Assembly Alert: 169

Subject: Fuel tank inspection

Models Affected: S-19

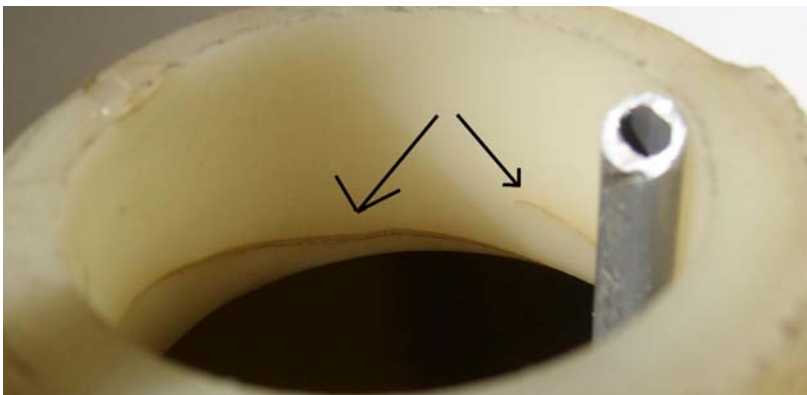
One builder of the S-19 has reported cracks around the base of the filler neck in one tank. Please inspect your tanks closely. The cracks in the photo appeared after leak testing and the dye in the fuel made them more apparent. Spotting cracks on tanks that have never been filled may require good lighting and a magnifying glass. Please inspect your tanks before and after installation, and periodically thereafter. Avoid inserting fuel nozzles into the tank and not supporting them, as this may cause cracking of the filler neck.
